REMARKS

This paper is submitted in response to the Office action mailed on April 8, 2010.

I. Specification and Drawing Amendments

Fig. 8

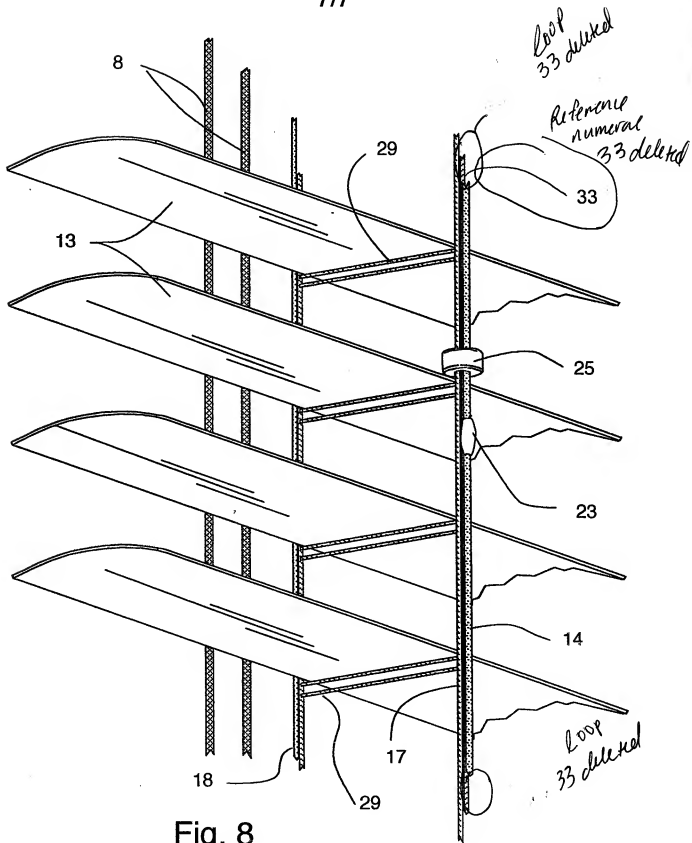
FIG. 8 of the drawings has been objected to for not being identified as "new," as required by 37 C.F.R. § 1.173(b)(3). By this Amendment and Response, FIG. 8 is added and labeled as a "New Sheet." Applicant respectfully submits that the new sheet of drawings complies with 37 C.F.R. § 1.173(b)(3). An annotated mark-up sheet, showing the changes to FIG. 8, is also attached.

FIG. 8 is further rejected under 35 U.S.C. § 112 for illustrating an additional vertical member between the first vertical member 17 and the tilt cord 14 that was allegedly not disclosed in the application as filed. Accordingly, as shown in the attached annotated mark-up sheet, this Amendment and Response deletes the vertical member between the first vertical member 17 and the auxiliary tilt cord 14 and formerly labeled as the conventional loop 33. The reference numeral 33 has also been deleted from FIG. 8. Applicant submits that the deletion of the additional vertical member is sufficient to overcome the Examiner's objection to FIG. 8 under 35 U.S.C. § 112.

The specification is objected to because the section "Detailed Description of the Preferred Embodiment," allegedly did not set forth a description of FIG. 8. Accordingly, Applicant has amended the portion of the Specification describing the embodiment shown in FIG. 8 to explicitly refer to FIG. 8.
